STAFF REPORT: 8/14/2024 REGULAR MEETING
APPLICATION NUMBER: HDC2024-00404
VIOLATION NUMBER: 912
ADDRESS: 677 W. CANFIELD
HISTORIC DISTRICT: WEST CANFIELD
APPLICANTS/ PROPERTY OWNER: MATTHEW ALLEN FLESZAR
DATE OF PROVISIONALLY COMPLETE APPLICATION: 07/22/2024
DATES OF STAFF SITE VISITS: 06/26/2024, 7/25/24

SCOPE: ALTER REAR DOOR AND WINDOW OPENINGS AND REAR PORCHES (WORK COMPLETED WITHOUT APPROVAL)

Figure 1, by Applicant, July 2024: (South) rear elevation location showing locations of work: red and gold boxed areas are included in this proposal, the green boxes indicate previously approved work and are excluded from this application.

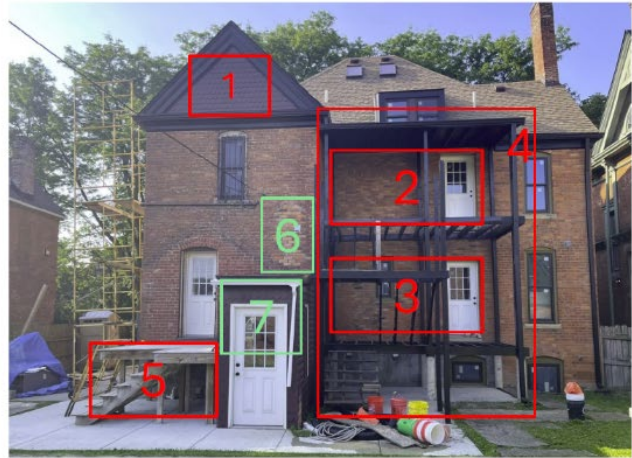
- As stated in the Elements of Design cited above, brick detailing is characteristic of this historic district. It is staff's opinion that the brick detailing above the arched windows and door openings are historic, distinctive character-defining features. Arches have been replaced with a rectilinear form with the replacement of windows to door openings in areas 2 & 3 (See figure 1, photos 2, 3-5.) In these areas smaller windows are placed where they appear to have impact where some of the arches remain, thereby impacting this distinctive character defining feature.

- It is staff's opinion that the brick detailing above the arched windows and door openings are historic, distinctive character-defining features. The original openings and arches over the windows at the rear 1st and 2nd floors have been replaced with door openings that have removed historic features that characterize this property. Additional smaller proposed windows appear to be located at areas where some of these brick arches remain. It is staff's opinion that this proposal in its current state is not in compliance with National Park Service Standards 2, 3, 4 and 5. However, it is staff's opinion that these features could potentially be retained or restored. (See figure 1, photos 2, 3-5.)

- The original openings and historic brick detailing of the door and window archways be preserved or restored when filled in with brick or replaced with a new window or door.

Figure 3, by Applicant, July 2024: (South) rear elevation side views, showing proposed balcony and stair footprints. Note that the missing 3rd story dormer is drawing error confirmed by the applicant.

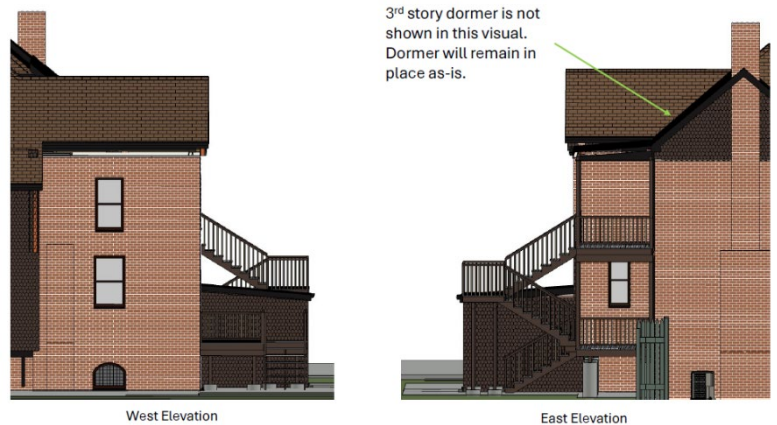
- Staff has no issue with the proposed window opening at the rear gable, which would restore a historic element that was removed without approval.
 - At this secondary, rear location, with a non-public view, it is staff's opinion that the proposed rear porches, balconies and stairwells meet the Standards and the Historic District's Elements of Design and are appropriate.

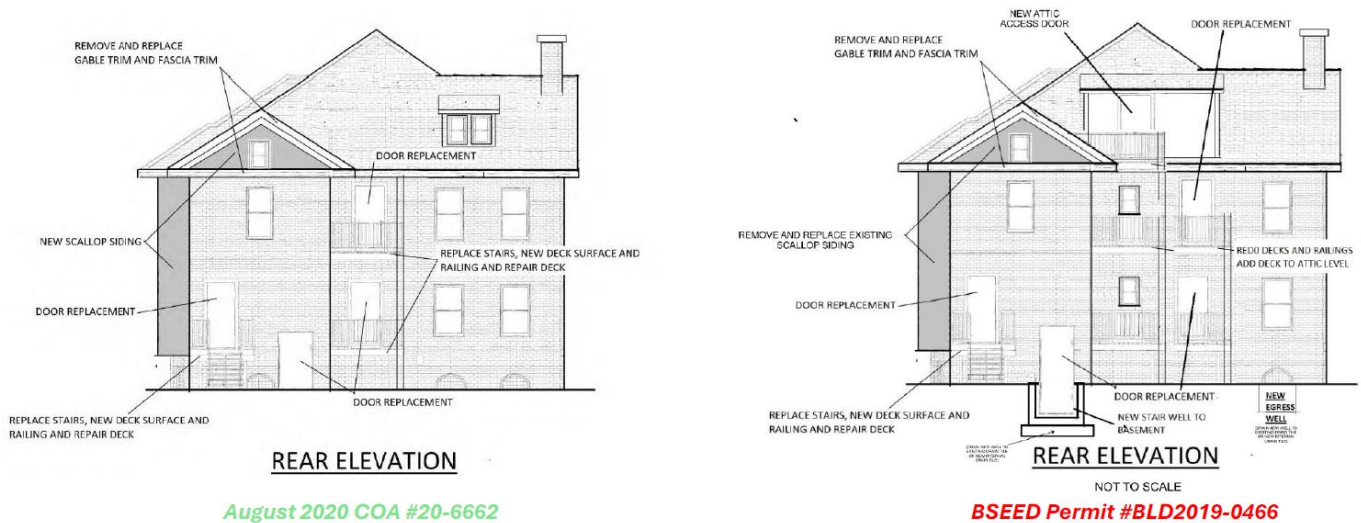
- In October 2020, a permit was issued in error by BSEED (see BLDG19-04662, figure 4) without HDC review. Staff requested information from BSEED and received the response that this permit was also certified under BLDG2021-02018. Under both permit numbers these drawings reference the 2020 HDC COA (#20-662), but the drawings of both rear elevations do not match. BSEED’s Supervisor of Plan Review offered the explanation that at the time of this application BSEED would process permits if there was a COA on file, but currently they require sign-off by HDC staff regardless of having a COA or not.

- The BSEED approved drawing shows a 3rd story alteration: the dormer is changed into an attic door with the balcony extending to this higher level. This drawing also shows the unapproved extension of the rear balconies and the alterations of door and window openings at the 1st and 2nd floors and a new egress basement stairwell. This work has started but not completed except for the 3rd story elements (never constructed). This 3rd story change is NOT in this proposal. Instead, the roof line over the second story is proposed to be extended to cover the rear balcony extension, leaving the rear dormer in place. Staff received confirmation from the applicant that this dormer will remain, even though the proposed drawing shows that it is missing as noted in the applicant’s final proposal. (See figures 1, 2, 4 and site photo 2.)
